PROJECT No. 1543760

CAPITAL POWER HALKIRK 2 WIND PROJECT ENVIRONMENTAL EVALUATION REPORT – ADDENDUM

Golder Associates Ltd. (Golder) is pleased to submit this addendum to the Environmental Evaluation (EE) for the Halkirk 2 Wind Power Project (the Project) submitted to Alberta Environment and Parks (AEP) on February 23, 2017. The supplemental information provided in this addendum address the clarifications requested by AEP during the meeting on March 14, 2017.

TITLE
T069 TO T069A RELOCATION

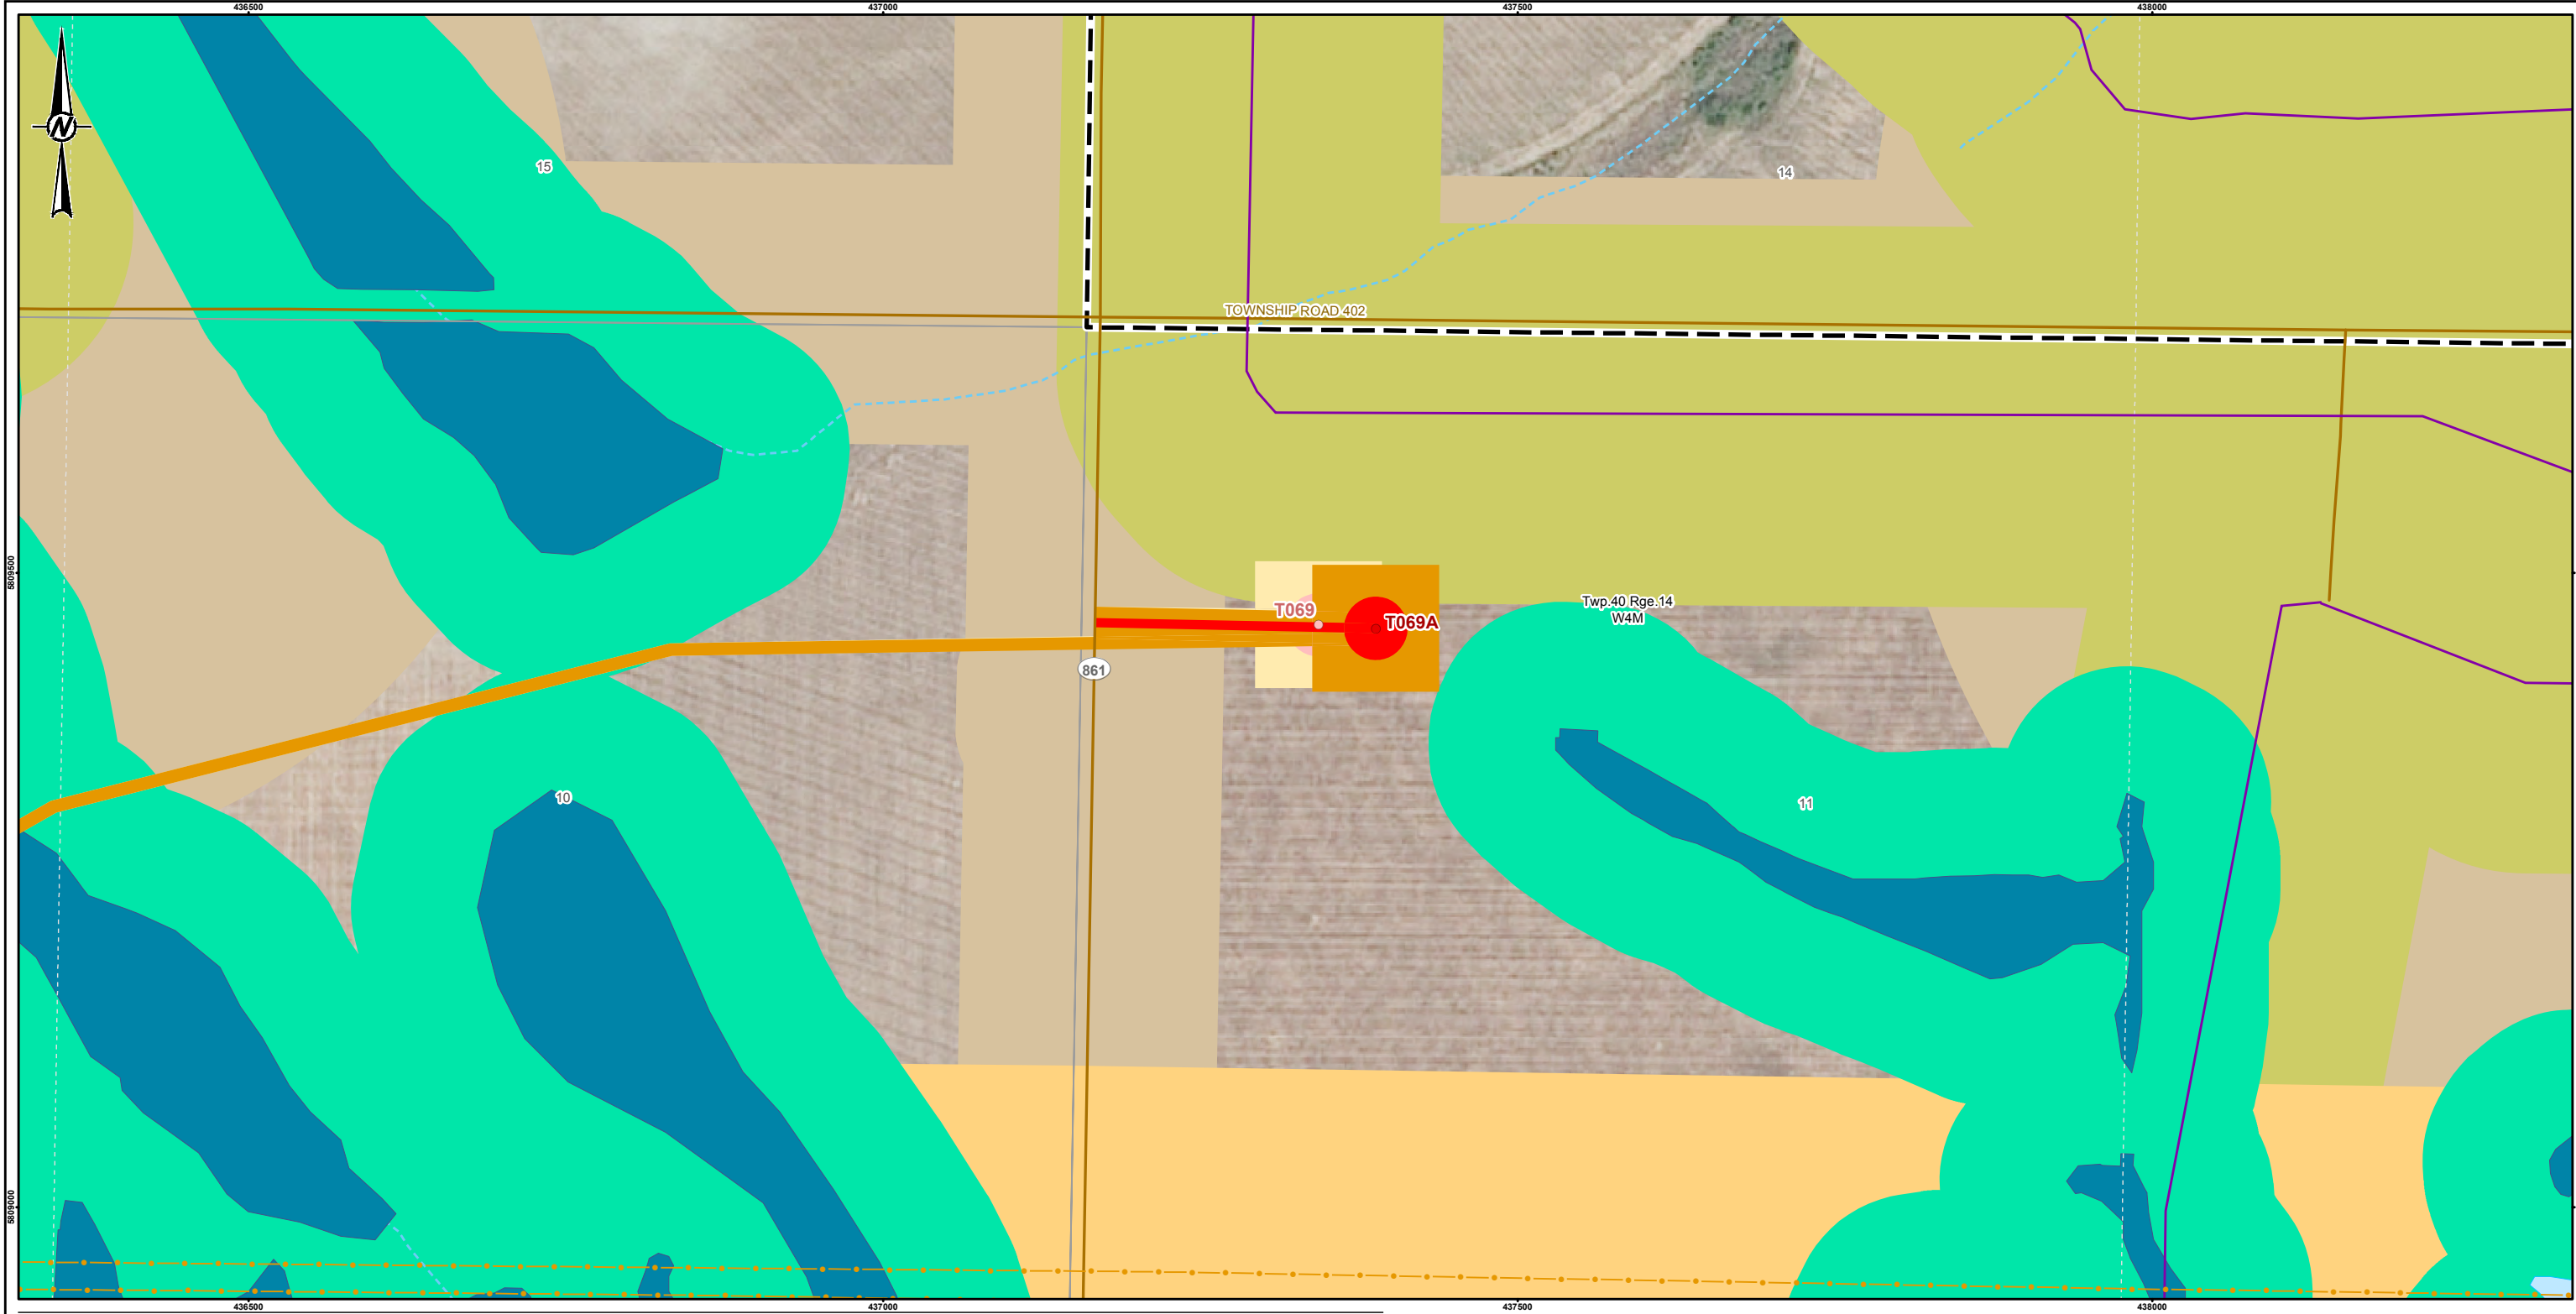
6. Alberta Transportation required that Project infrastructure meet the minimum setback distance of 150 meters from the Highway 861 right-of-way to issue a permit.

To support Alberta Transportation Roadside Development Permit issuance, Capital Power moved turbine T069 outside the minimum setback requirement of 150 meters from the highway right-of-way. The new turbine location, T069A, was relocated 45 meters east of the original location (Figure 1) and its associated access road, crane path and collector system were slightly extended to accommodate this request from Alberta Transportation.

Avoidance of wetlands is the primary mitigation employed during construction and operation of the Project by Capital Power; therefore; turbine T069A and its associated Project components have been re-sited to avoid both permanent and temporary effects on wetlands. Additionally, no indirect impact to wetlands is anticipated from this change as the nearest Project component is located 98 m from the nearest wetland.
